VALIDATION REPORT TITLE

Project Title	2x50 MW Orange Suvaan Solar Photovoltaic Power Project in Maharashtra, India
GS ID of Project	5928
Version of the Validation Report	03
Completion date of the Validation Report	31/12/2024
Date of Design Certification	01/08/2018
Version number of the corresponding Design Certification	NA
Project Representative	Infinite Environmental Solutions limited
Project Developer	Greenko Suvaan Energy Private Limited
Project Participants and any communities involved	NA
Activity Requirements applied	Renewable Energy
Scale of the Project Activity	Large Scale

VKU Project ID	VKU.VAL.16.24_GS_5928
Prepared By	VKU Certification Private Limited
Contact	Regd. Off: Prakoshth Number No. 1-S, Leaf Tower, Second Floor, Plot No. 01, IRIS LEAF Gram Talawali Chanda, Indore 453771 (M.P.) India URL: https://www.vkucertification.com/ E-mail: info@vkucertification.com
Authorized by	Dr. Vikas Kumar Aharwal (Founder and Director) vikas.aharwal@vkucertification.com
Work carried out by	Barun Kumar – Team Leader/ Validator/Verifier cum Technical Expert T.A.1.2 KM Nisha Chauhan- Validator/ Verifier- Trainee Megha Modi- Project Trainee Sunil Kathuria – Technical Reviewer and Sector

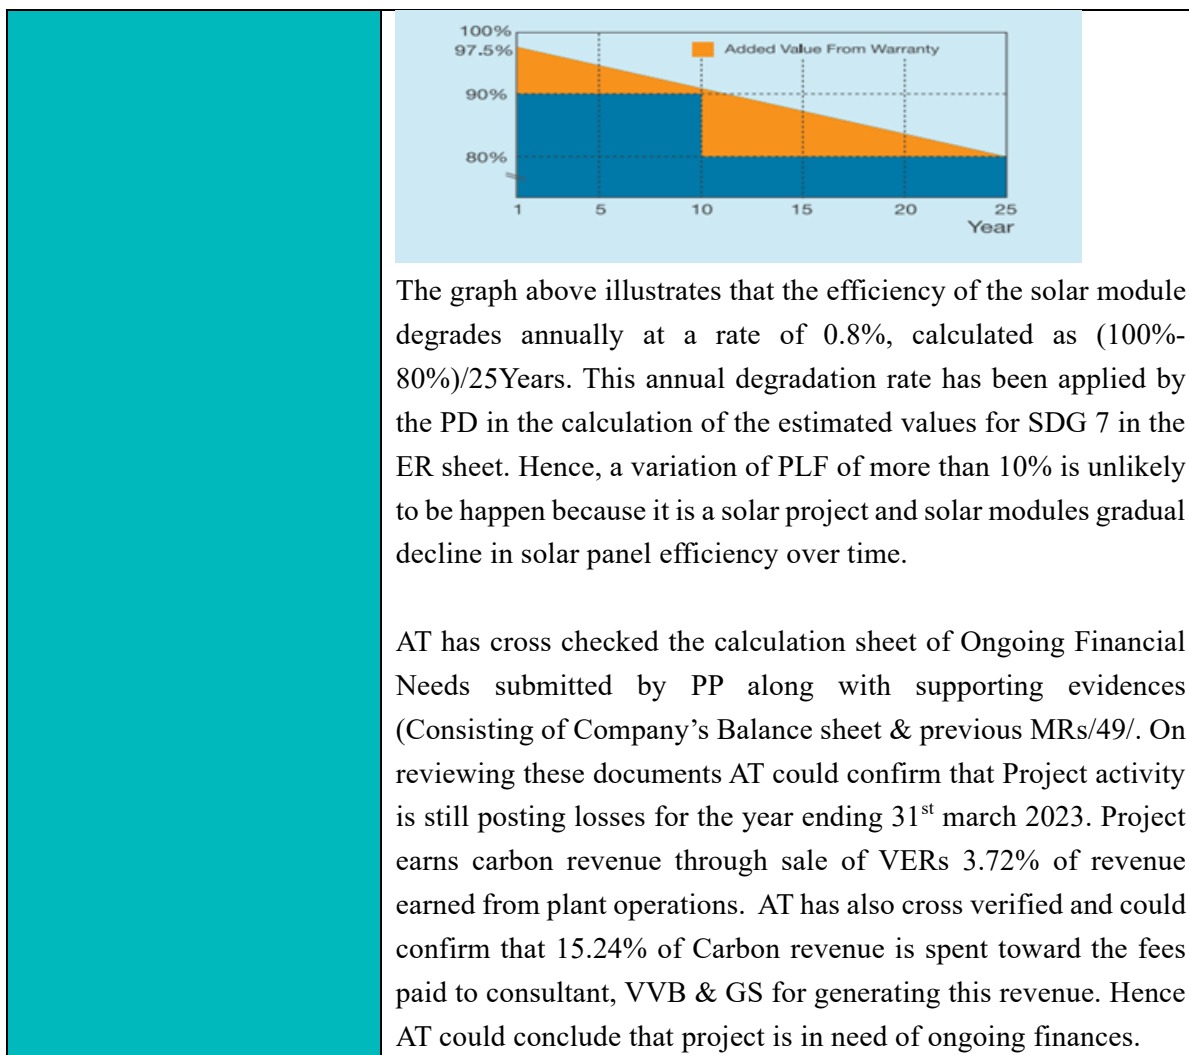
In the IRR sheet, the Project Developer has updated the PLF value to align with the first crediting period, resulting in a change from 19.25% to 23.17%. This adjustment was made in accordance with Clause 2.1.6 of the document titled "Assessment Approach for Reporting Higher Ex-Post Emission Reductions" (Version 1.0). Upon applying the revised PLF in the IRR sheet, the IRR has been recalculated to 14.04% (only for PLF) while other values remain unchanged. This value remains below the benchmark IRR of 16.05%. Additionally, the benchmark of PLF, as specified in the registered PDD, is 24.67%. Based on the new PLF, the variation required to reach the benchmark PLF is 6.50%.

Given that this is a solar project, it is important to note that solar modules typically experience performance degradation over time. Therefore, a substantial increase in the PLF to breach the benchmark is highly improbable.
